GREATER NEW HAVEN WATER POLLUTION CONTROL AUTHORITY

IMPROVING FATS OIL AND GREASE RECEIVINGS

Project SSF 2020-03

ADDENDUM #3

DRAWING NUMBER
M-00-602
SHEET NUMBER
66 OF 109

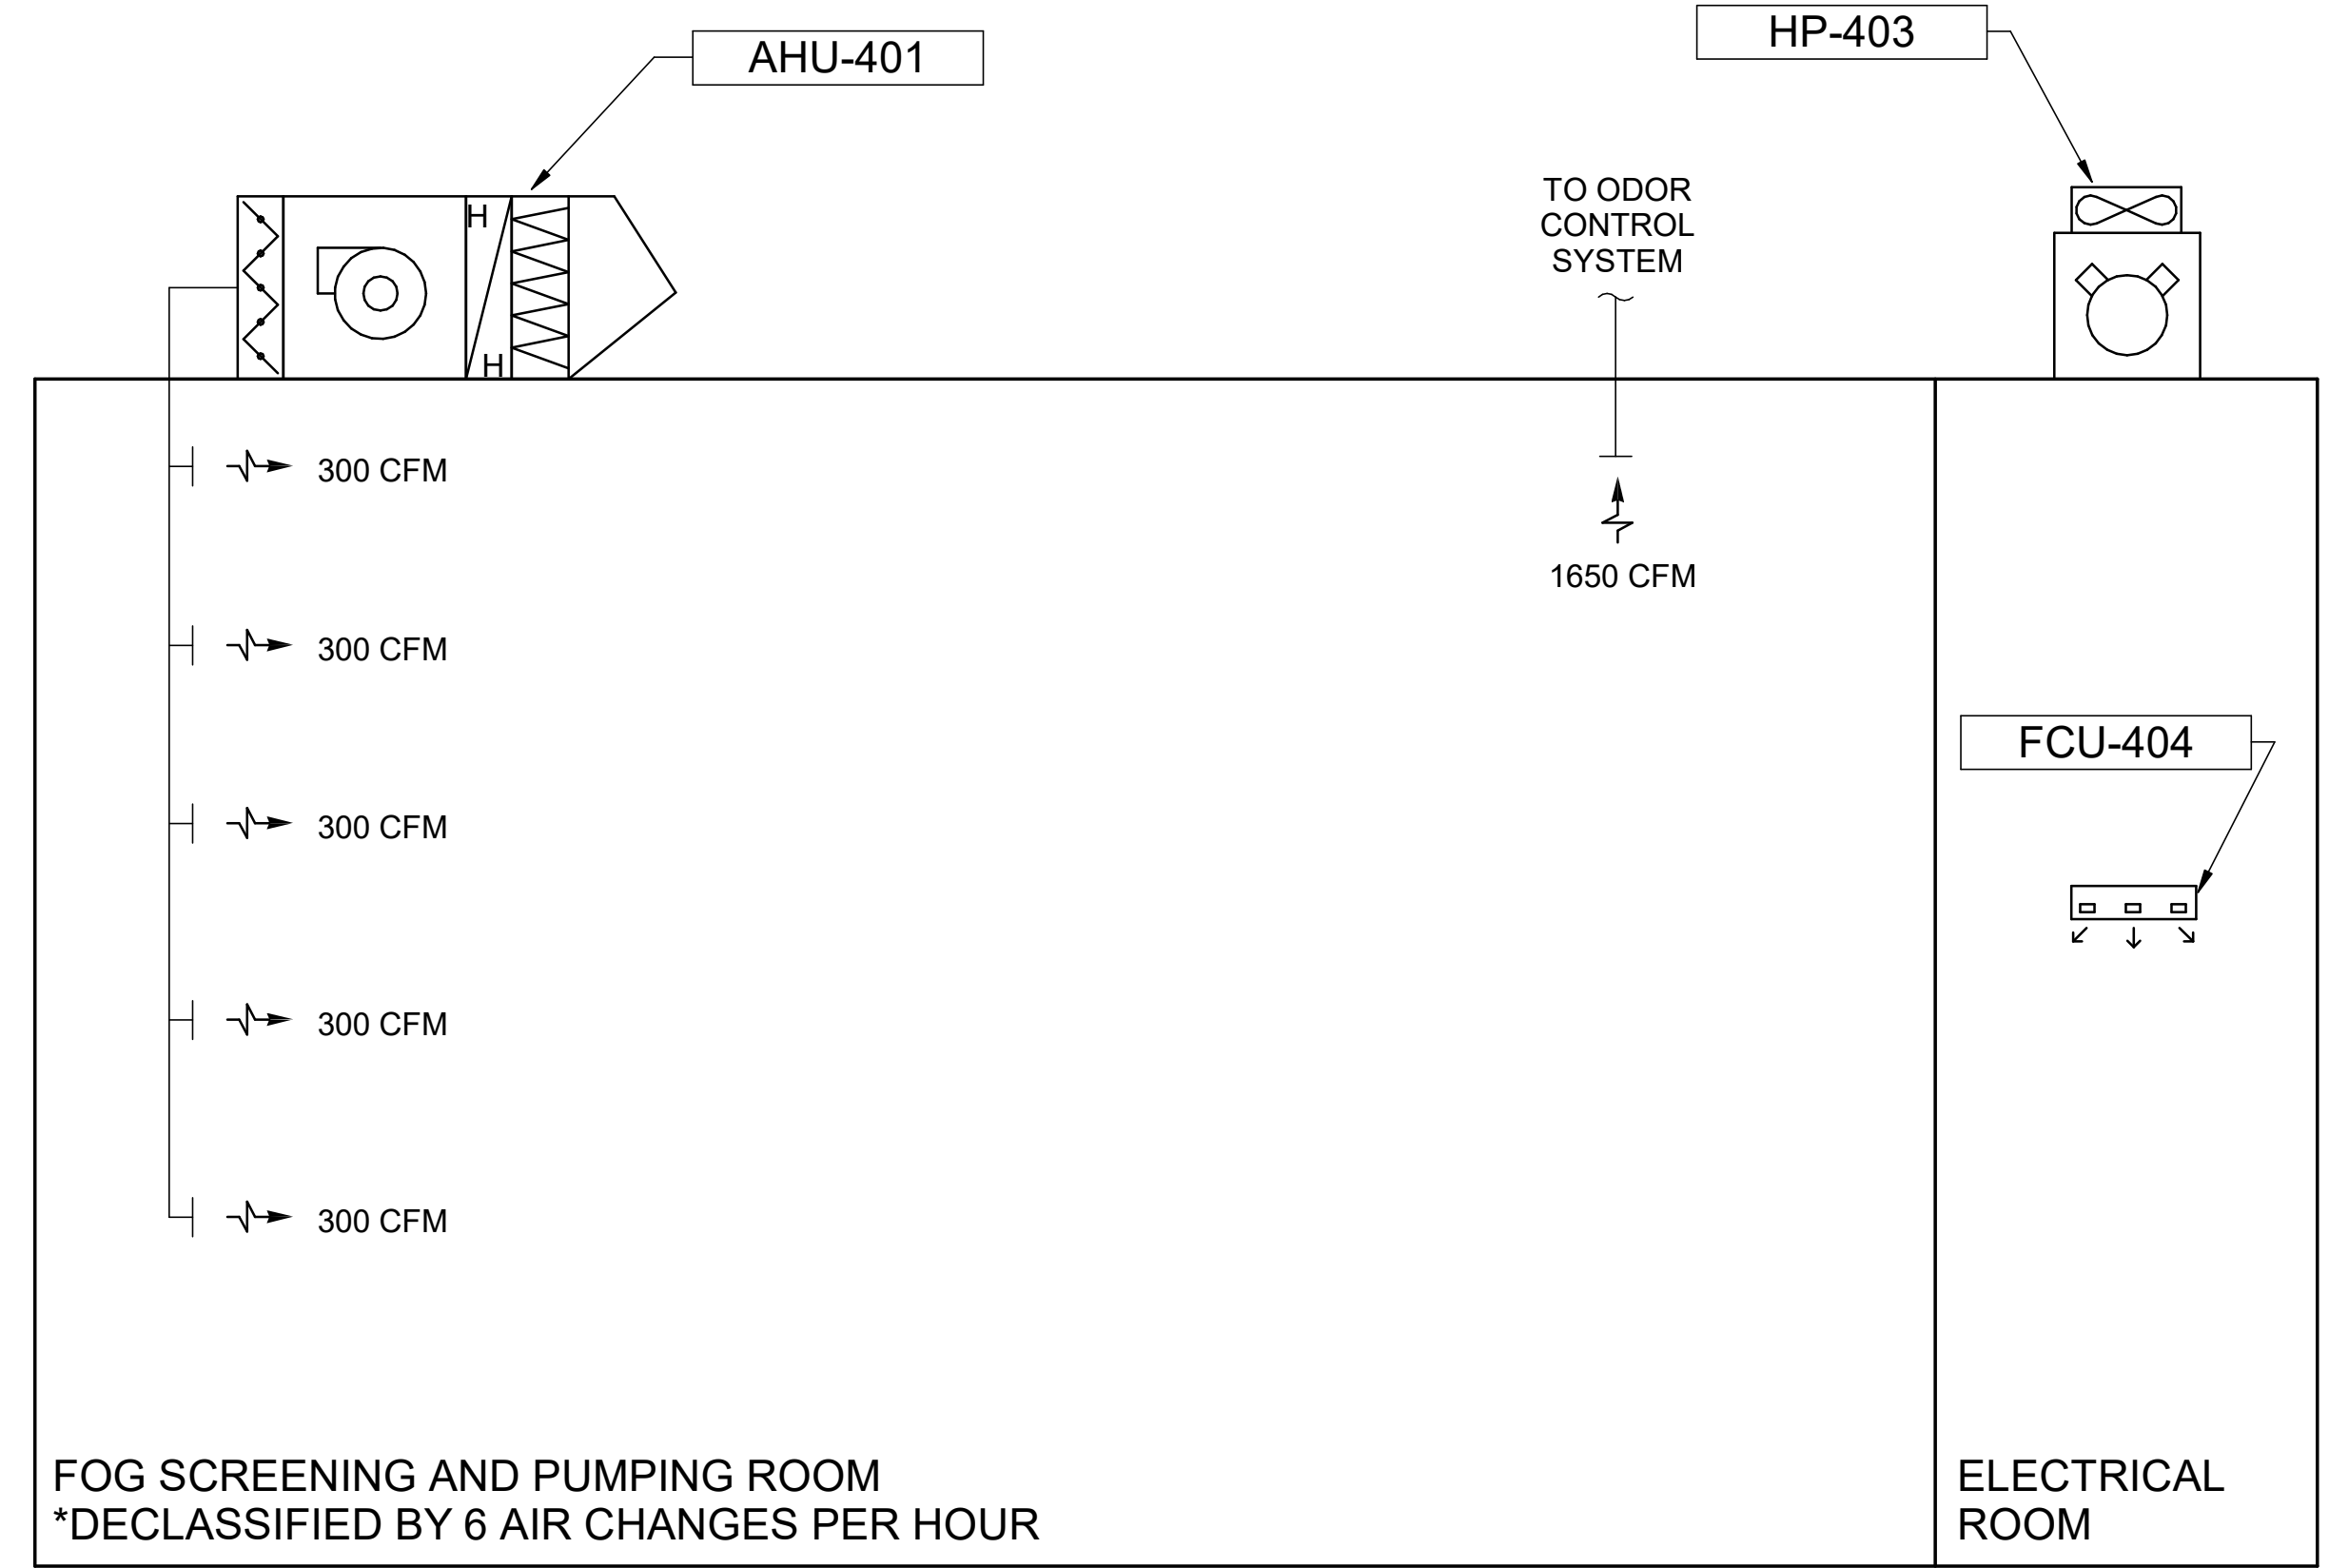
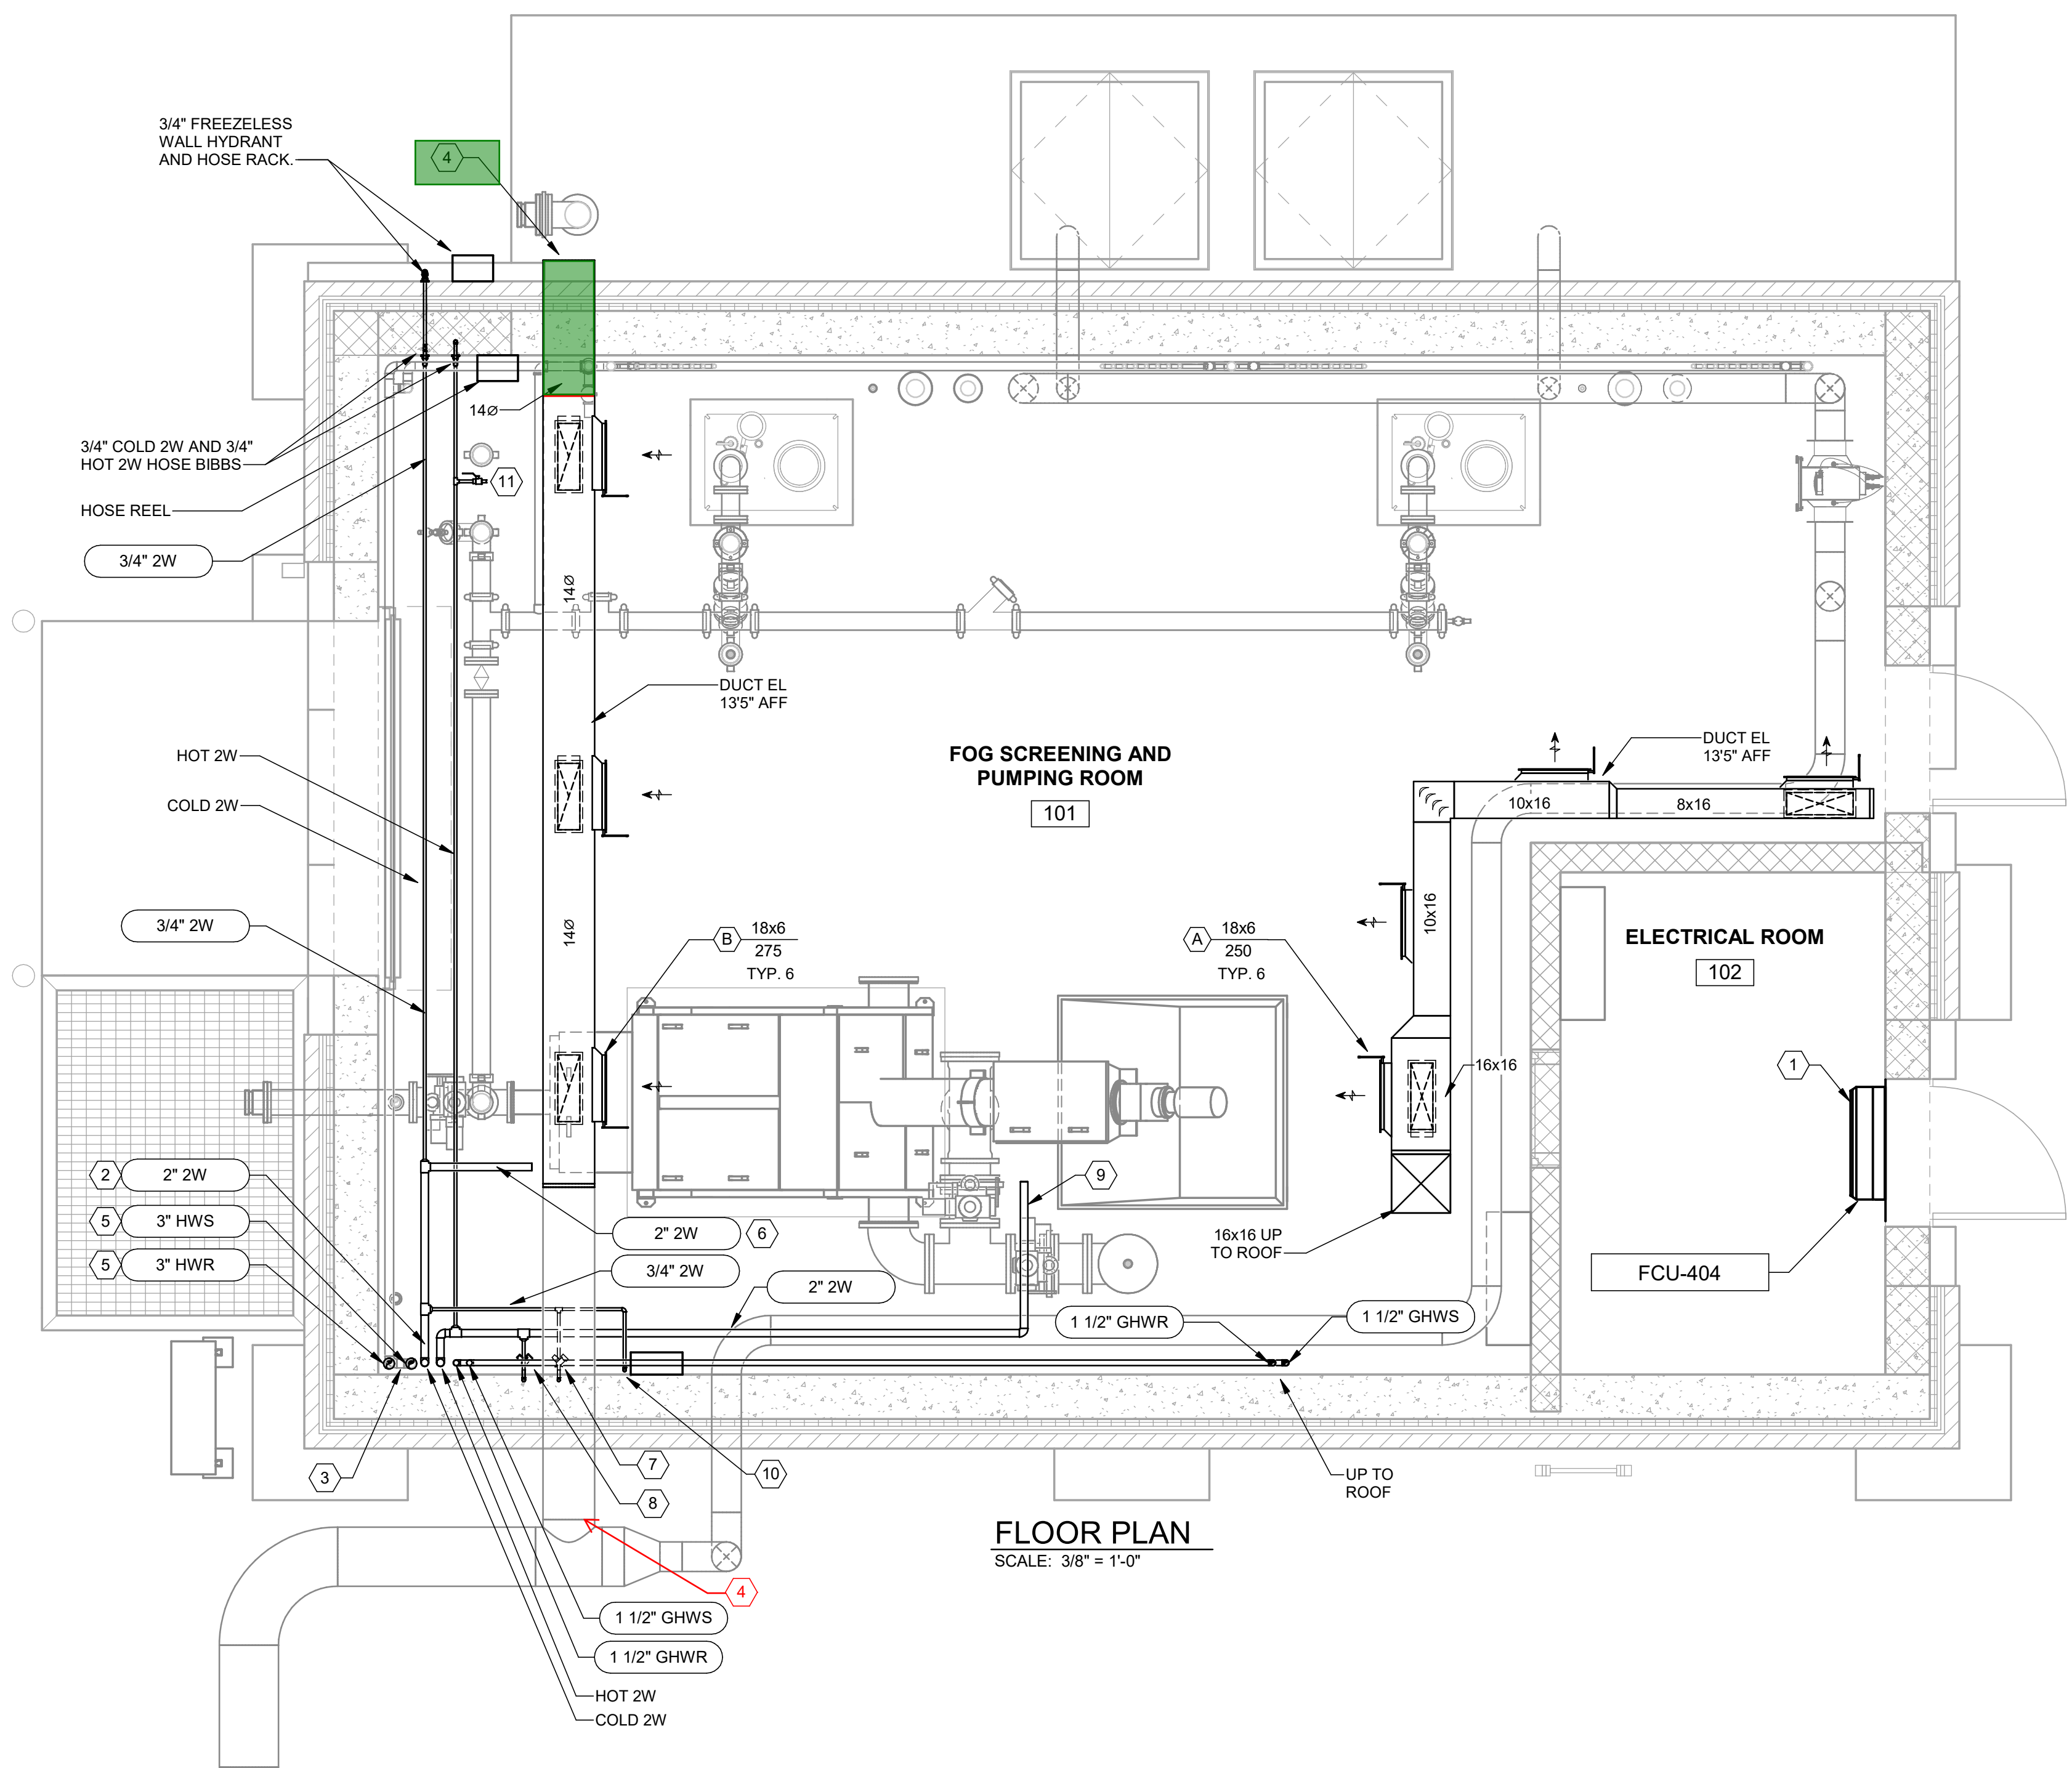
1. **Question:** Drawing M-00-602 - Regarding the closed loop served by pump P-310 on the on the FOG Tank side of HX-401. Should there be an air separator, expansion tank, auto feeder & backflow preventer on the closed loop?
- i. **Response:** Yes, refer to updated drawings M-00-601, M-00-602, M-78-101, and M-80-102.

DRAWING NUMBER
M-63-101

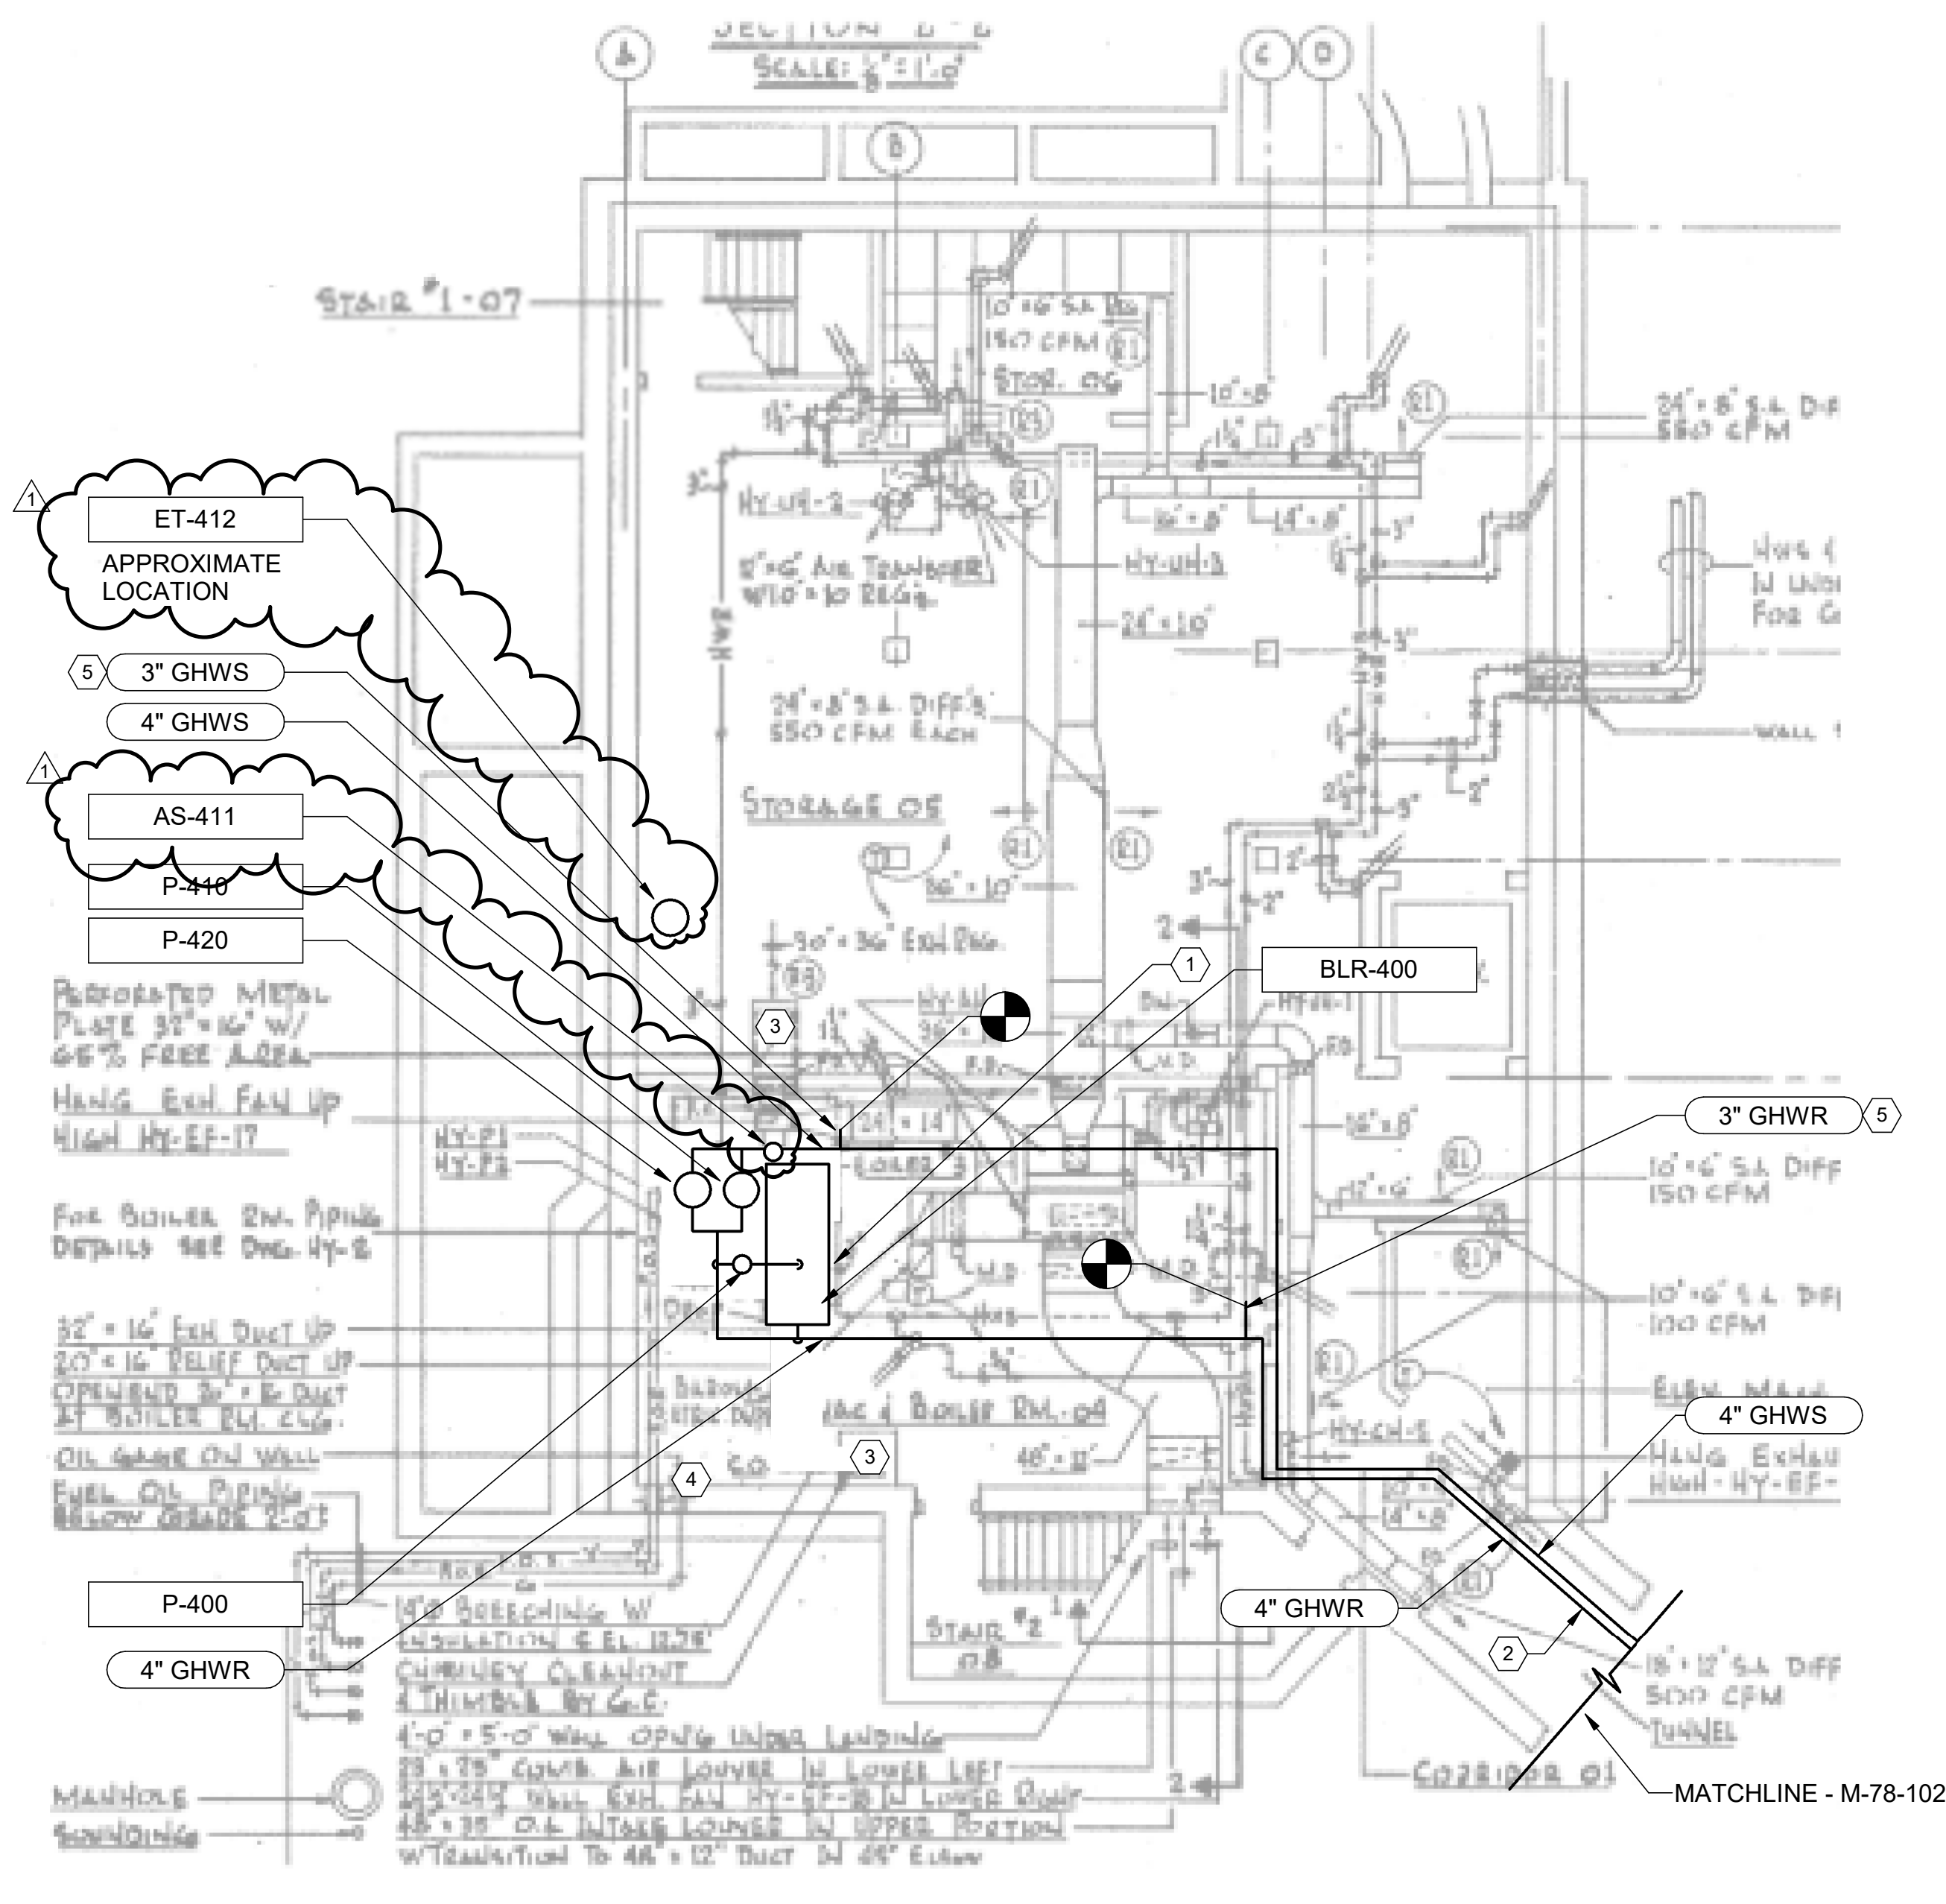
- i. **Response:** Confirmed, FRP shall be used for rectangular ductwork.
11. **Question:** Drawing M-63-101 shows the return ductwork going through the North wall and has a note indicating to connect to 16" FRP ductwork yet there is ductwork there, please confirm if this is correct.

- i. **Response:** No, the duct shall stop at the interior north wall. See attached markup.
